Supplement #3

THE FINAL SUPPLEMENT TO THE  
"ENGINEERING EVALUATION OF THE WNP-2  
SACRIFICIAL SHIELD WALL" SUBMITTED TO NRC  
IN AUGUST 1980

Fig 1. LINEAR INDICATION IN RING 3 AT 135°-150° AZ

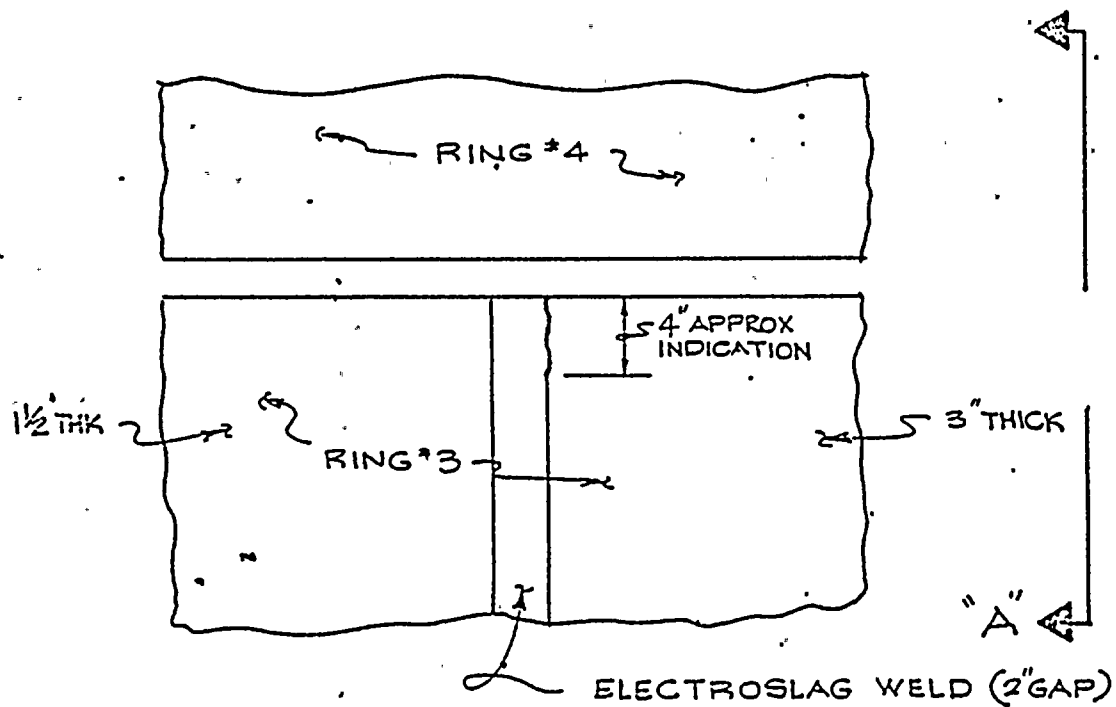
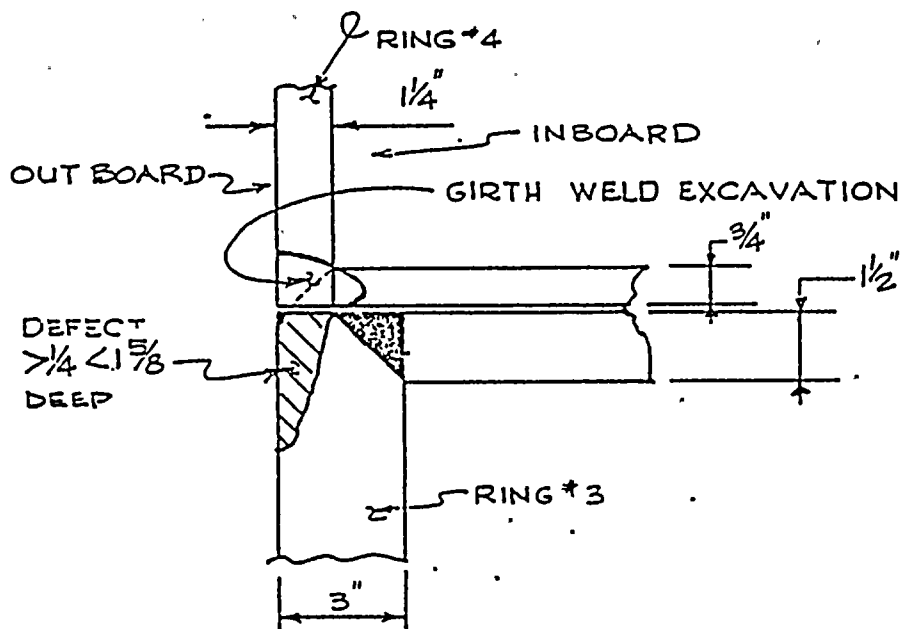
- (i) Linear indications in electroslag welds were discovered adjacent to the girth weld. Details of this deficiency are given in Figures 1 and 2. This deficiency was detected in two of the thirty-two electroslag welds in ring #3 which intersect the girth weld.
- (ii) Linear indications, slag inclusions and porosity were discovered in guide plate welds (see Figure 3).
- (iii) Lack of penetration existed at the weld joint between the bottom flange of ring beam #4 and the exterior web plate. Details of this deficiency are shown in Figure 4. For further discussion and clarification see Part 5.
- (iv) Linear indications in the girth weld excavation probably resulted from the repair of deficiency (iii) above.

These deficiencies are discussed in detail in Ref. 11. It is concluded that the nature and severity of the deficiencies observed during the girth weld repair are bounded by the assumptions of Ref. 1 and that their discovery does not influence the conclusions of Ref. 1 with respect to the integrity of the SSW under design loading conditions.

FIG. 4. LACK OF PENETRATION AT AZ. 90°-105°, 0°-15° AND 180°-195°.

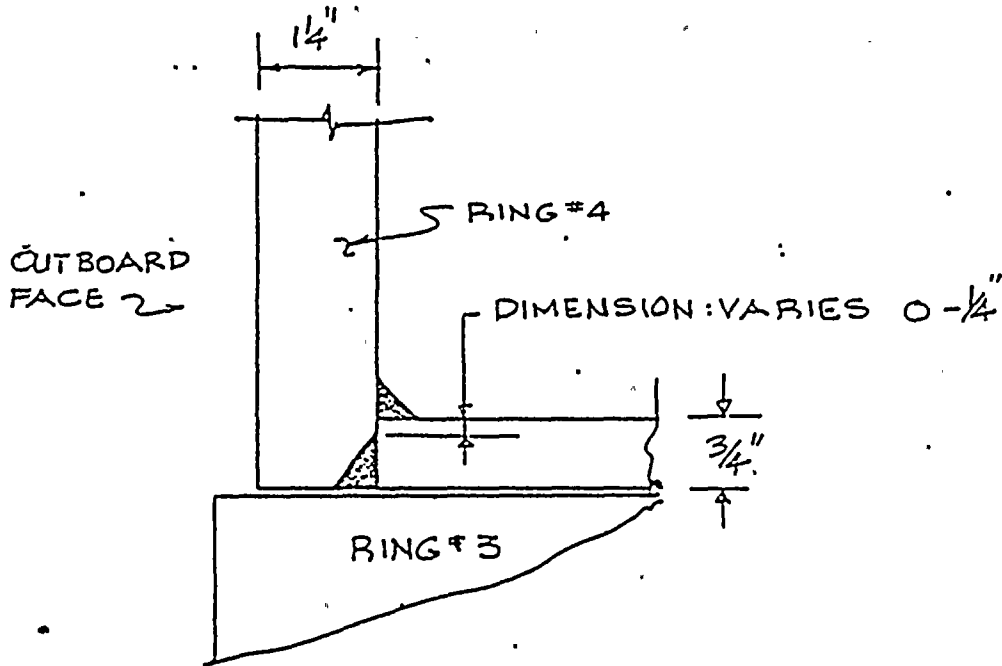
5.1 The Engineering Evaluation of the WNP-2 Sacrificial Shield Wall Supplement No. 2, Part II.C identified three locations where incomplete penetration (I.P.) was discovered in the partial penetration flange-to-web plate weld on ring 4. (See Figure 4 of this supplement). The incomplete penetration identified was 1/4" deep; however, the original report addressed 5/32" as the worst I.P. case in Table III D.5.

In comparing the a/t ratio of 0.33 for the 1/4" I.P. in 3/4" thick material to Table III.D.2, there are no a/t ratios in either the static loading or the dynamic loading columns for any of the materials equal to 0.33. Therefore, plastic collapse will not occur. An a/t ratio greater than 0.5 would have to occur before plastic collapse could occur.

In addition, the potential for plastic collapse is reduced by the design of the SSW. For plastic collapse to occur, large strains and displacements are required. The SSW is a redundant structure in that loads are transmitted through many members in parallel. The displacement which can be applied to a weld joint is limited by parallel joints. The design and the evaluation for plastic collapse leads to the conclusion that the 1/4" I.P. will not cause plastic collapse and is enveloped by the original assessment of the wall.

Table III.D.5, attached, is revised, reflecting the 1/4" incomplete penetration, and a corrected typographical error for undercut.

FIG. 5 TRANSVERSE MACROSECTION THROUGH ELECTROSLAG WELD  
P.W. 2504 # 4

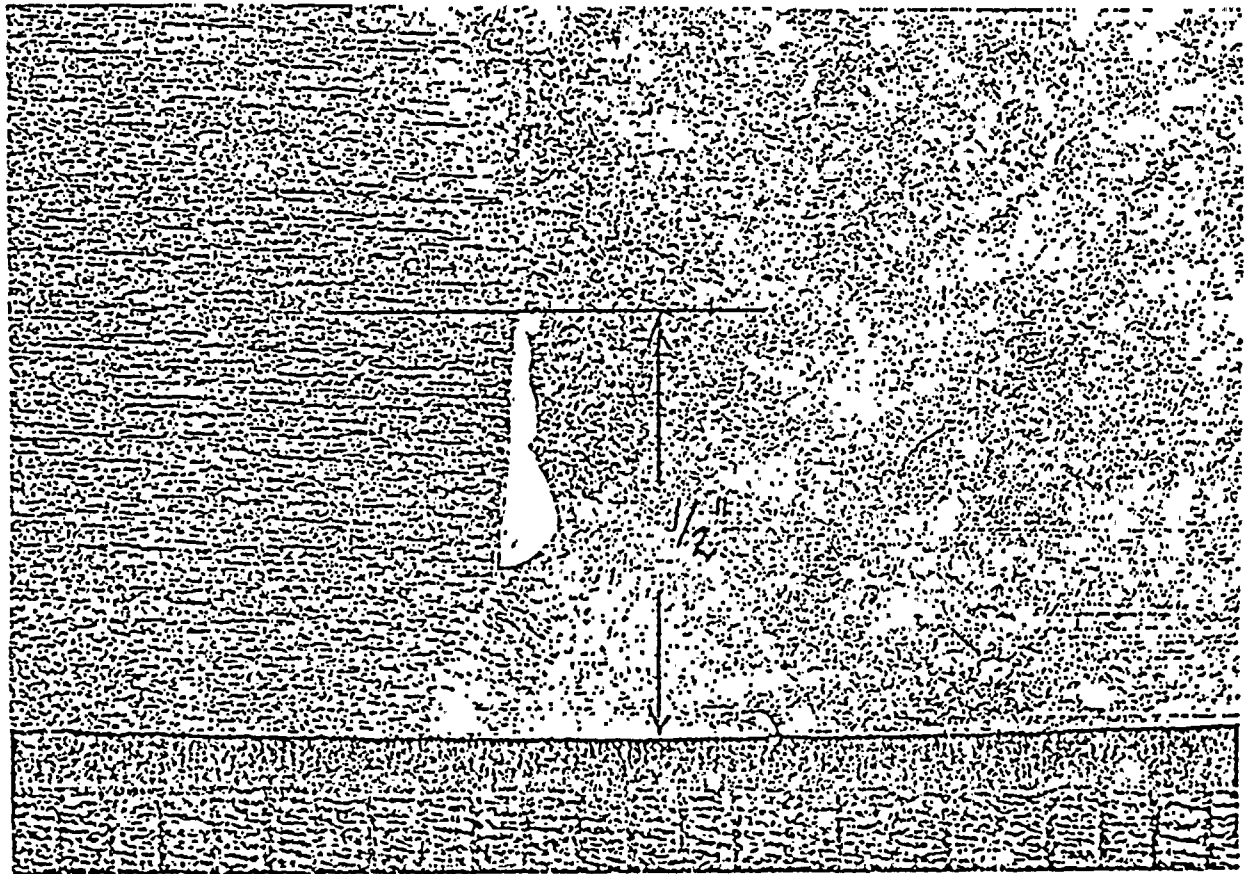
Prior to machining drop weight test plates, the sample was examined by UT and sectioned for macroscopic examination. A subsurface defect was found which extended along the length of the sample. The nature and extent of the defect is shown in Figure 5. It consists of a lack of fusion defect on the sidewall of the weld which originally extended in from the surface of the weld, but was partially excavated and repaired.

In addition, two similar, but shallower defects were observed on the other side of the weld (Figure 5).
